Lower Yonge Precinct

Municipal Class Environmental Assessment Study
Consultation Summary from the Public Information Centre

Harbour Street: Freeland Street - Lower Jarvis Street (Facing East)
3 - Lane + Bi-Directional Cycle Path + Parking Lane (27.00m R.O.W.)
PRELIMINARY PREFERRED

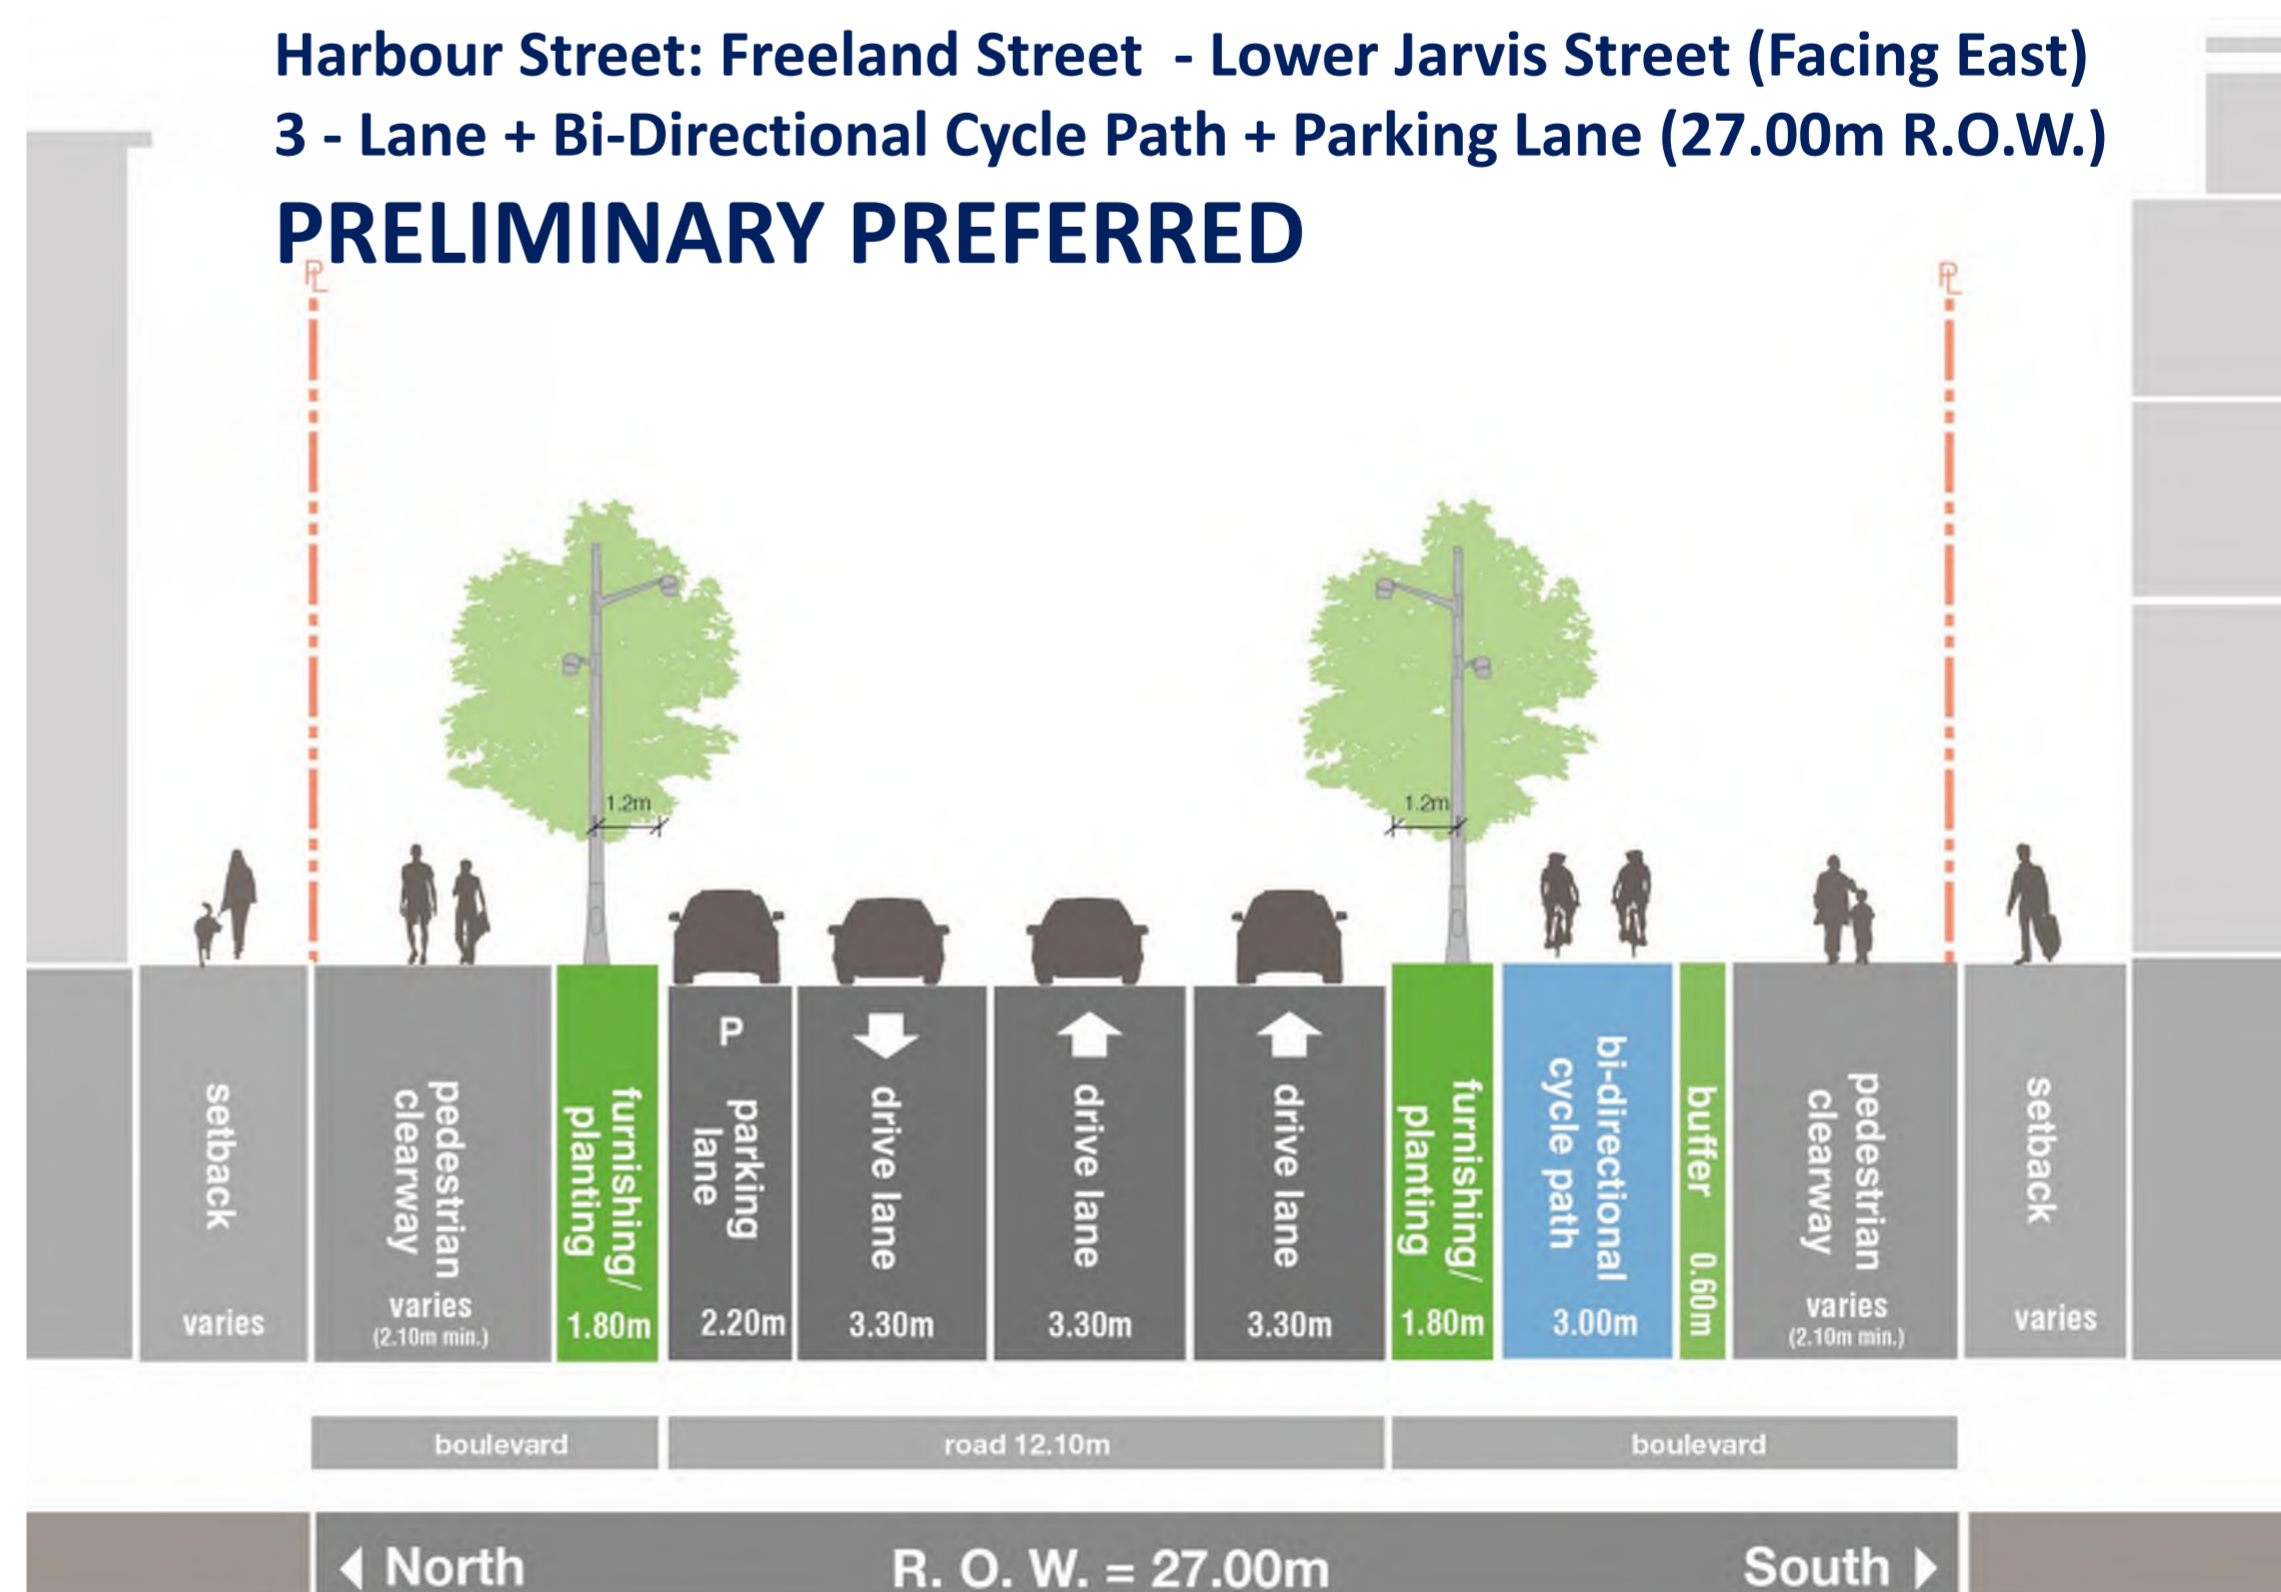
There is no building setback along Harbour Street from Yonge Street to Lower Jarvis Street. Edits will be made to the cross sections to correct this.

Yonge Street: North of Lake Shore Blvd – Railway Corridor (Facing North)
4-Lane + Uni-Directional Bike Lanes + Median (24.50m R.O.W.)

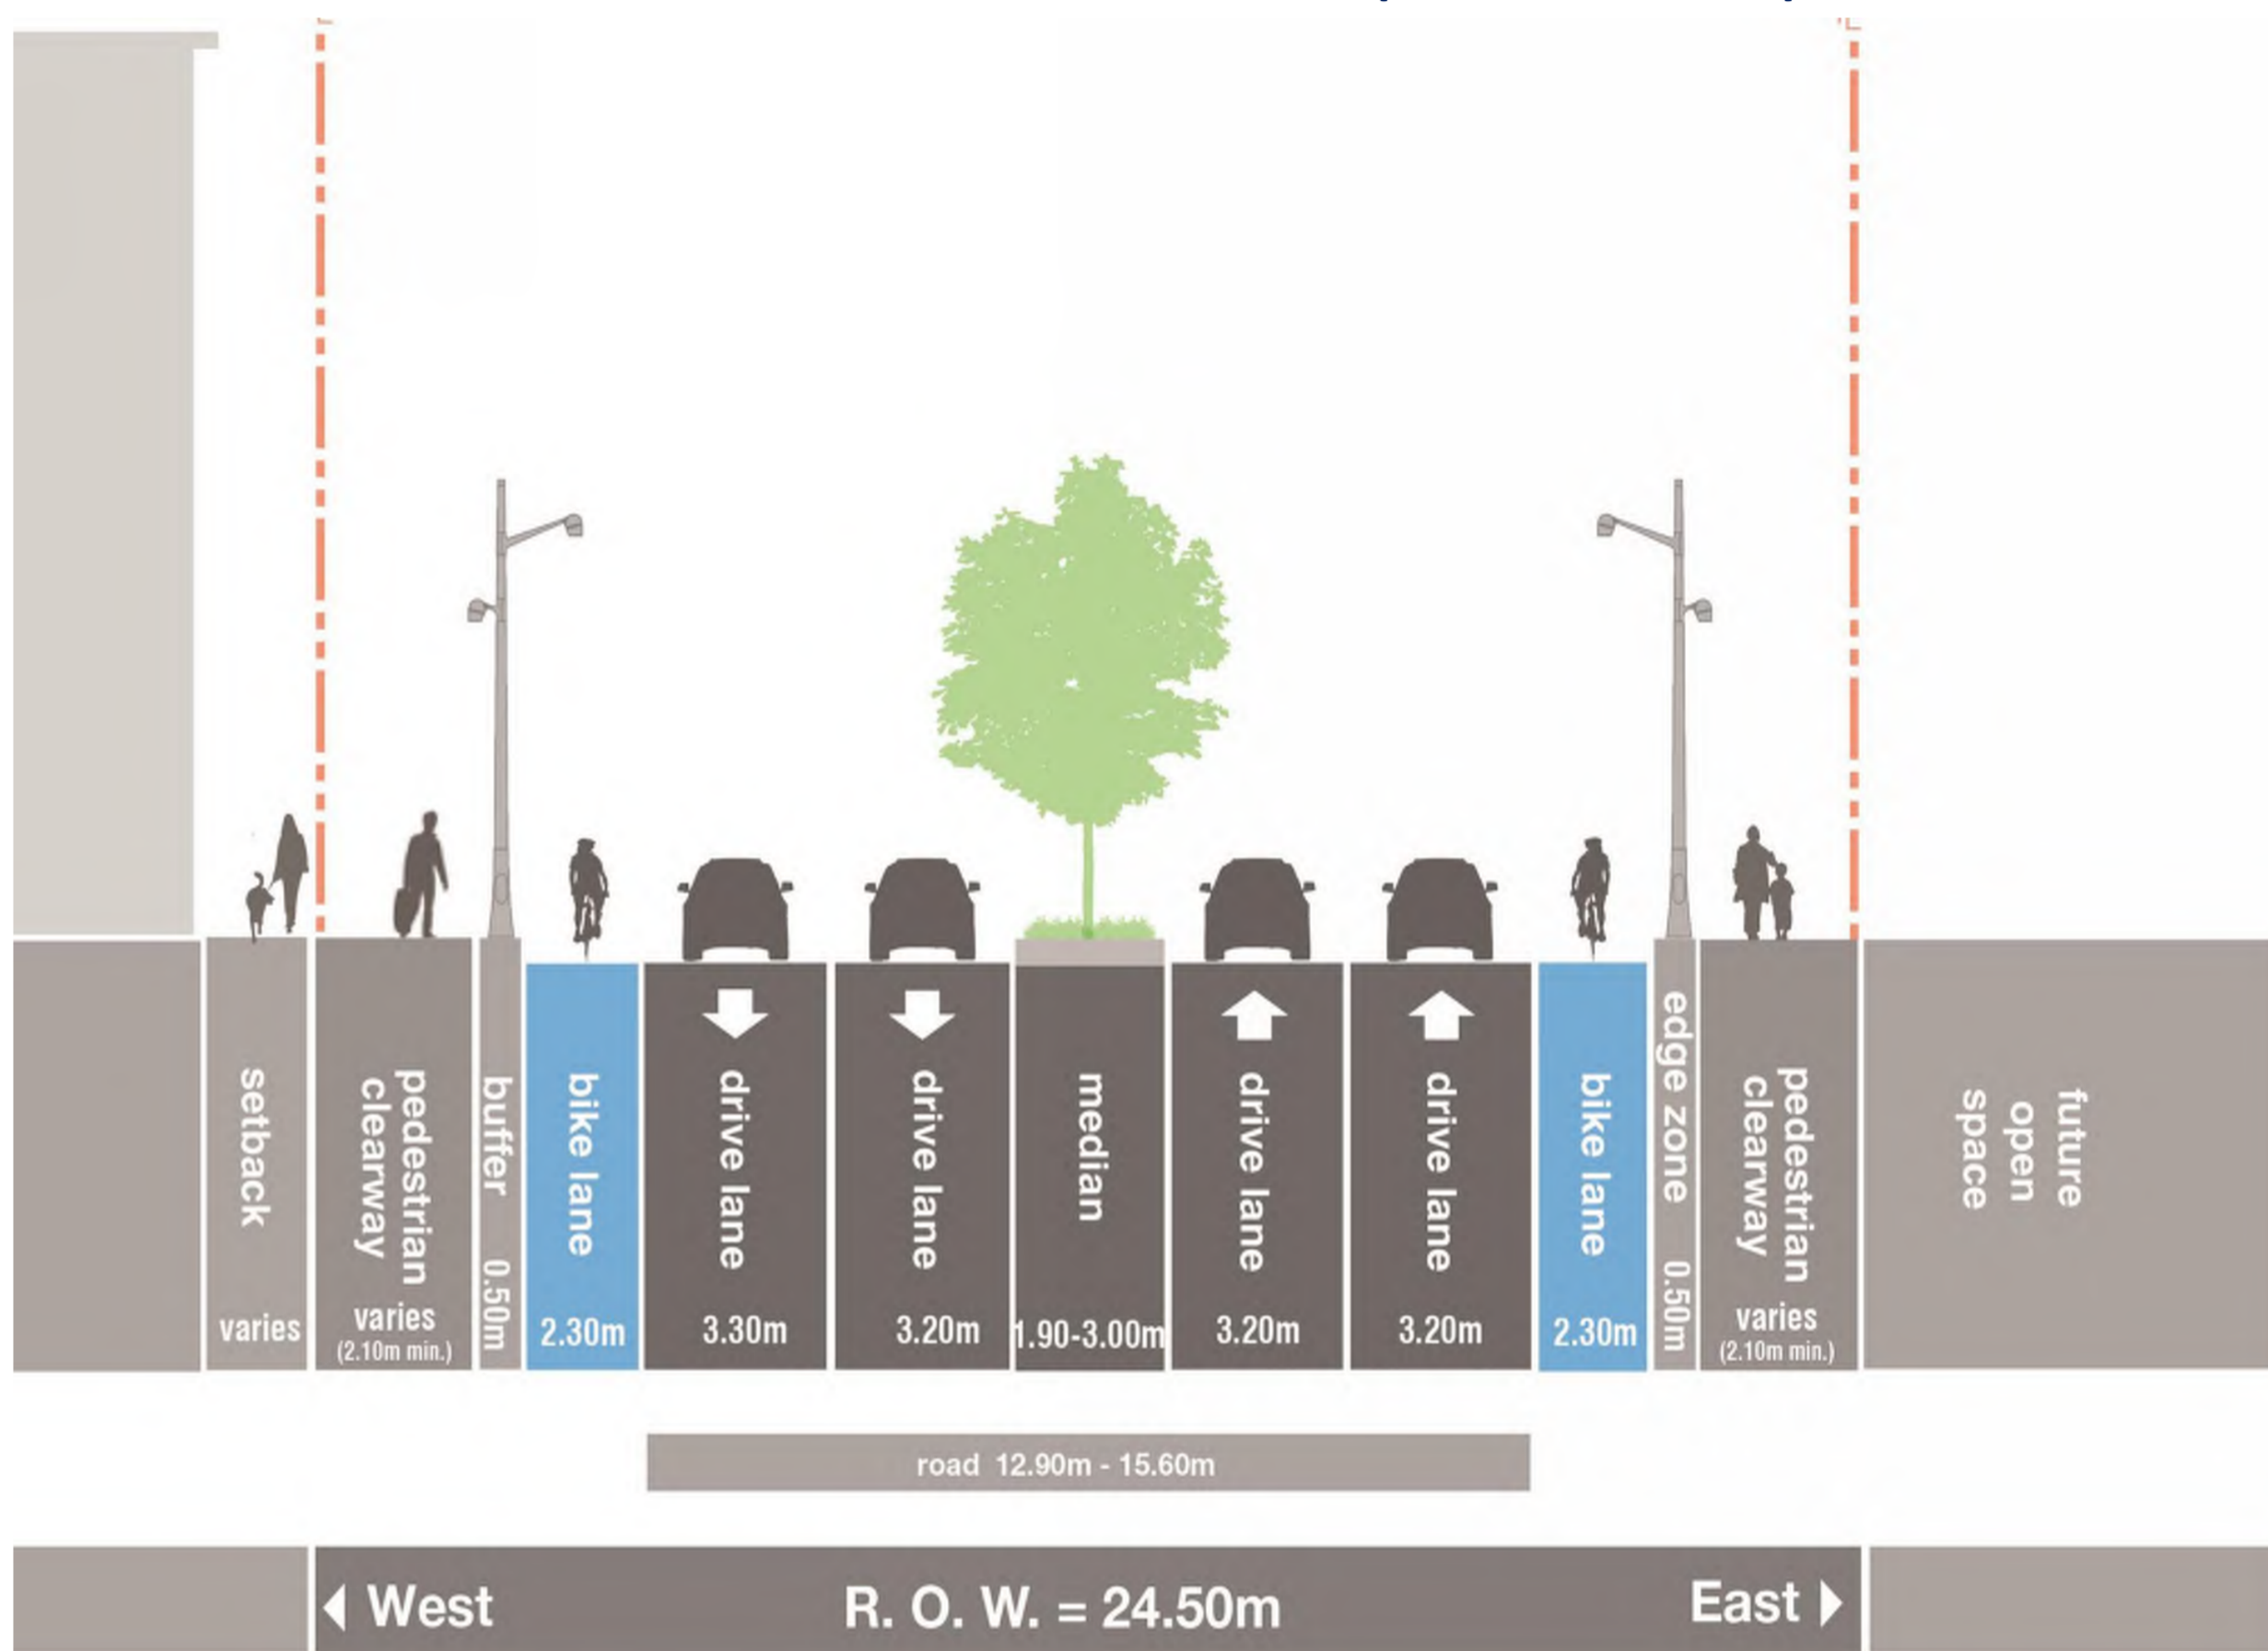
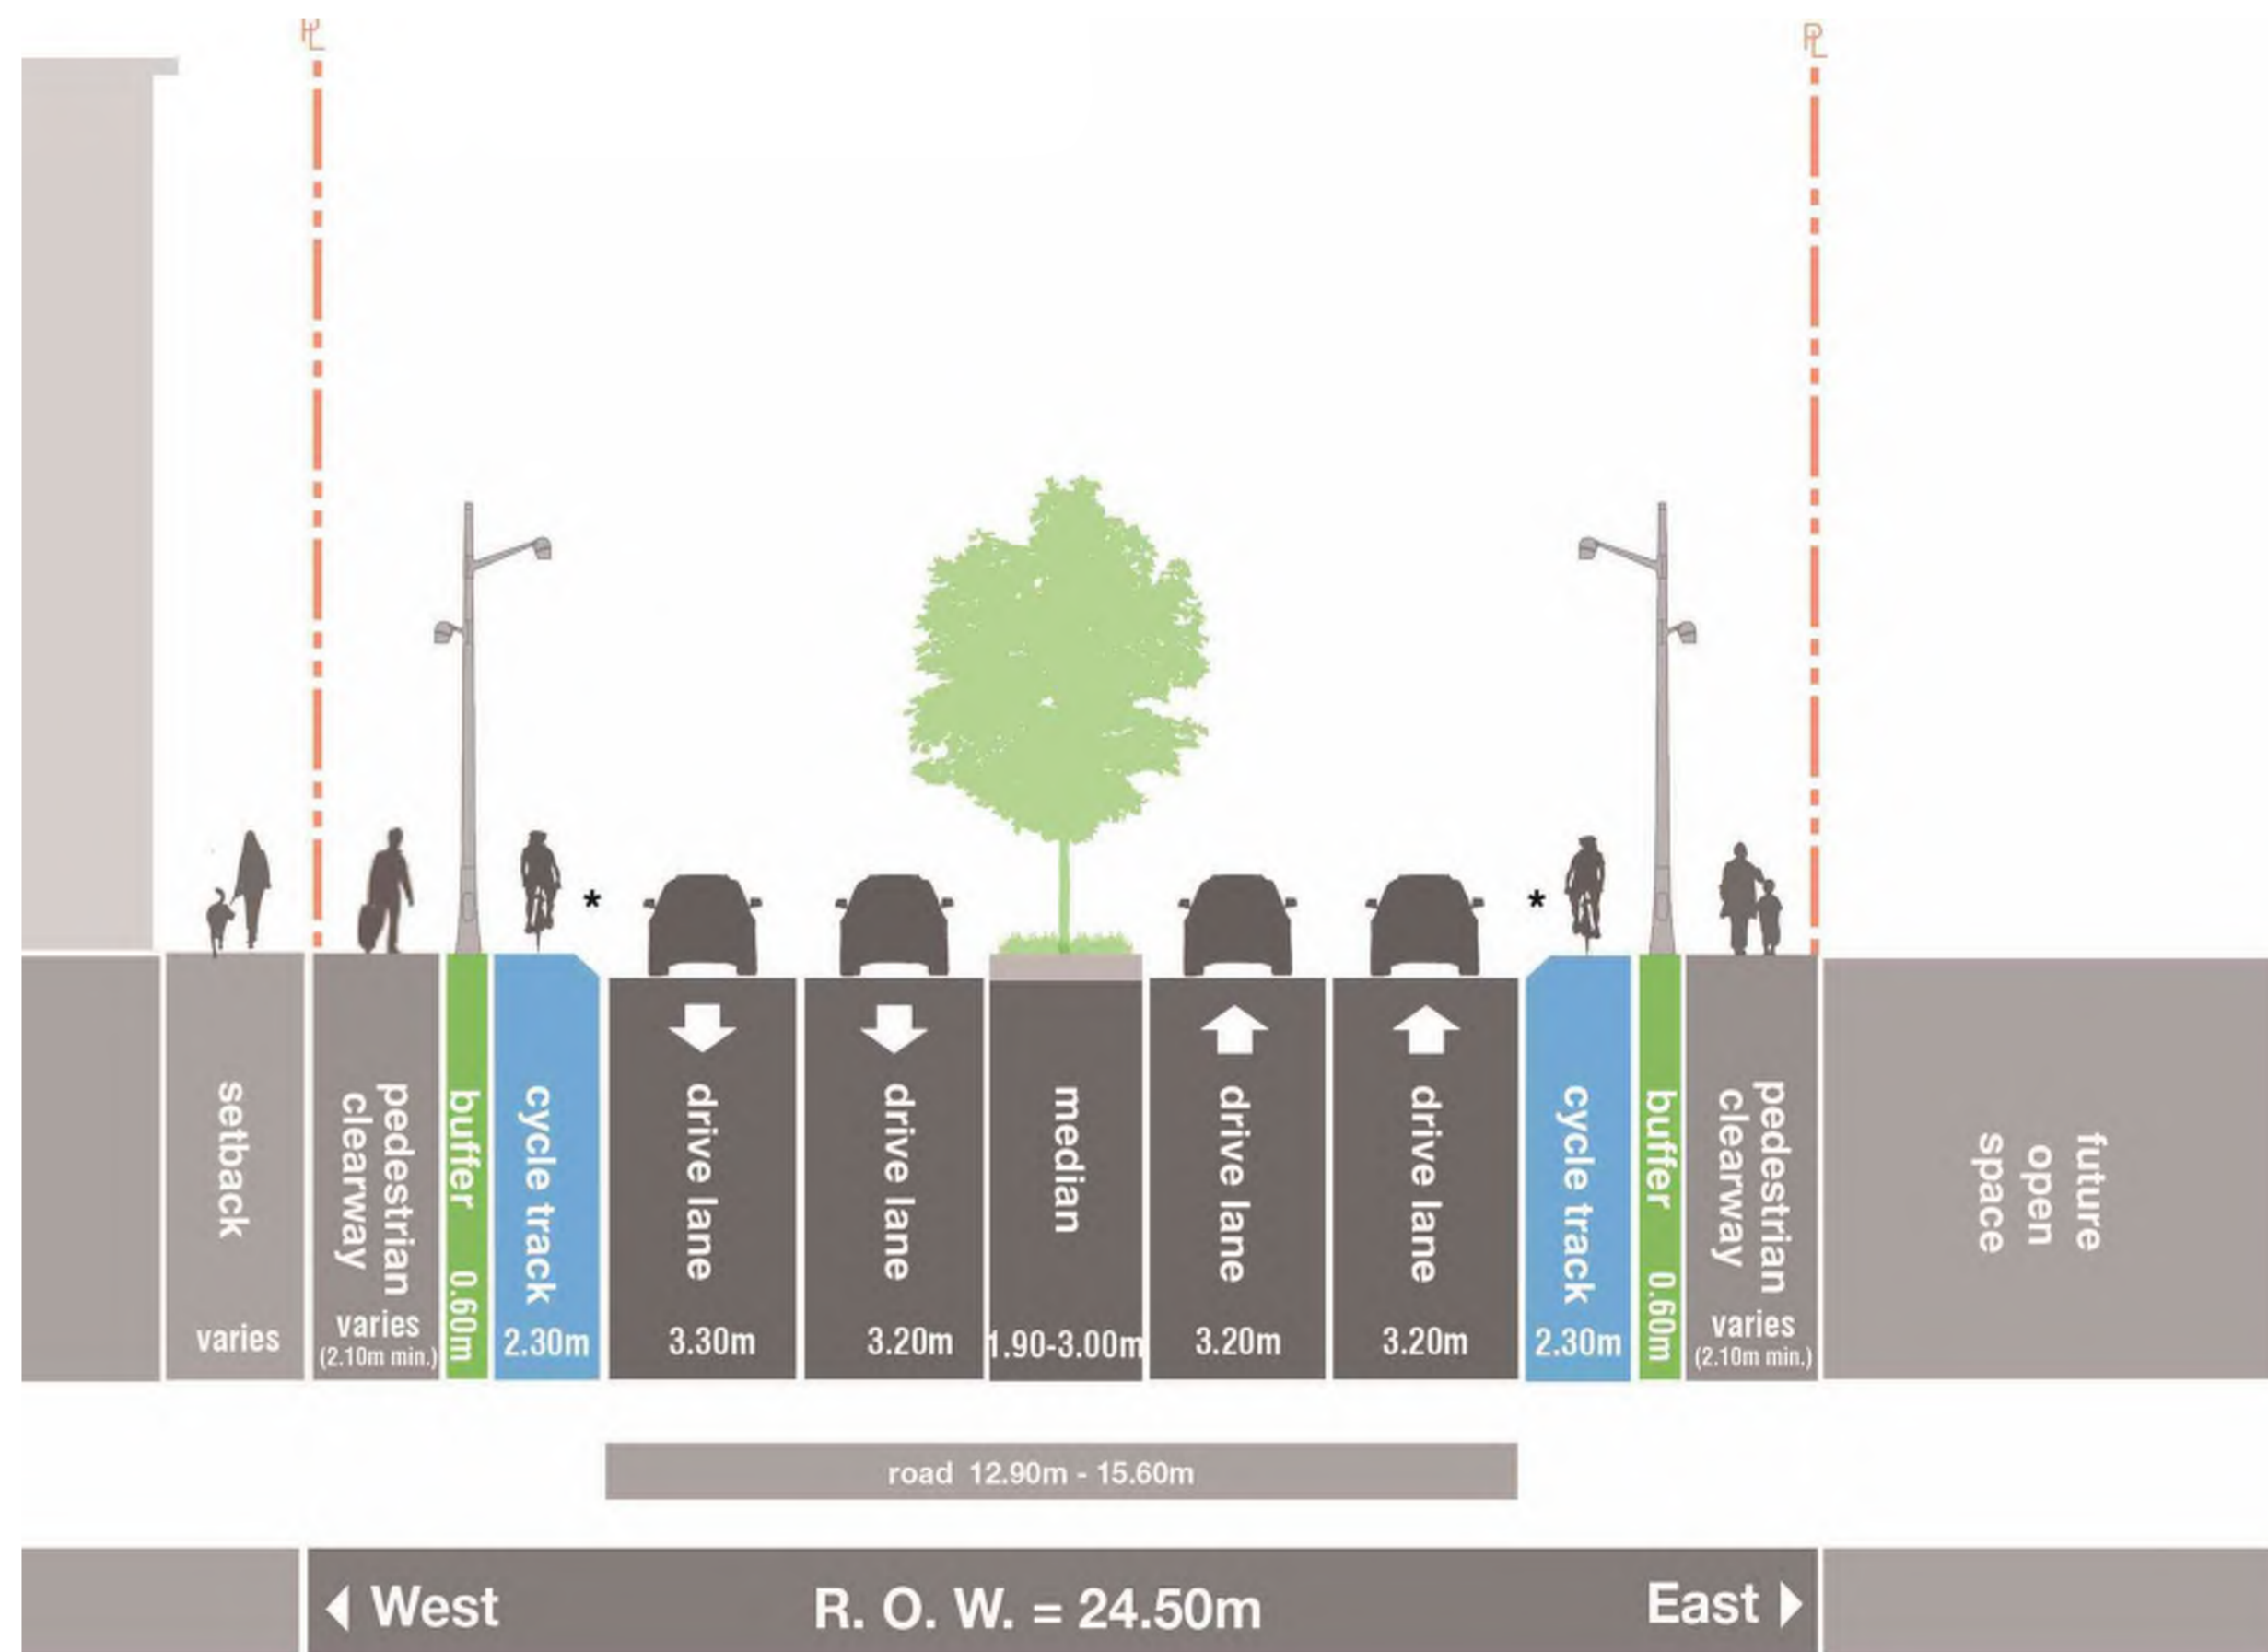
- ▶ Concern that bike lanes are too narrow for Yonge Street, a major arterial.
- ▶ Concern that the location of bike lanes is unsafe and located close to the travel lanes (“mini highway”).
- ▶ Suggestion to modify the width of the travel lanes from 3.3 m to 3.0 m, and to provide an additional buffer for the bike lanes. Alternatively, the bike lanes could become a cycle track.

Cycling facilities with mountable curbs are elevated from the roadway and do provide an element of separation. The preliminary preferred alternative along Yonge Street through the rail corridor should provide increased level of comfort and safety when compared to the standard bike lanes that currently exist along Yonge Street. Mountable curbs are required along Yonge Street from Lake Shore Boulevard to north of the rail corridor because of physical constraints posed by the rail structure and the need for vehicles to pull over to allow sufficient passable space for emergency vehicles.
